## **BID ADDENDUM NO. 4**

### **CONSTRUCTION NEW GEORGE WYTHE HIGH SCHOOL (RHSA)**

**IFB # 23 – 7061 – 11  
RRMM Project # 21310 – 00**

**January 9, 2024  
Architect of Record:  
RRMM, Architects, PC  
1317 Executive Boulevard  
Suite 200  
Chesapeake, VA 23320  
Phone: 757-213-6350**

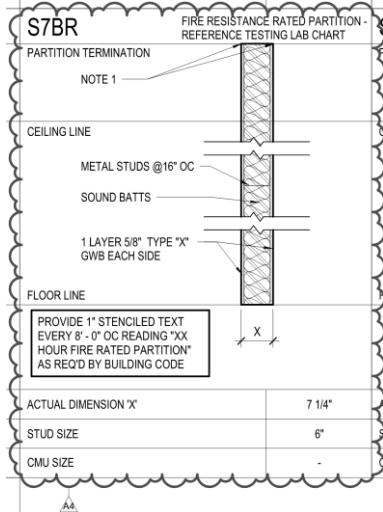
- Testing Lab Chart - **ADD** partition type **S7BR** with UL #**U419** listed under 1 Hour Rating column.
- **ADD** partition type **S7BR** to partition types legend as follows:
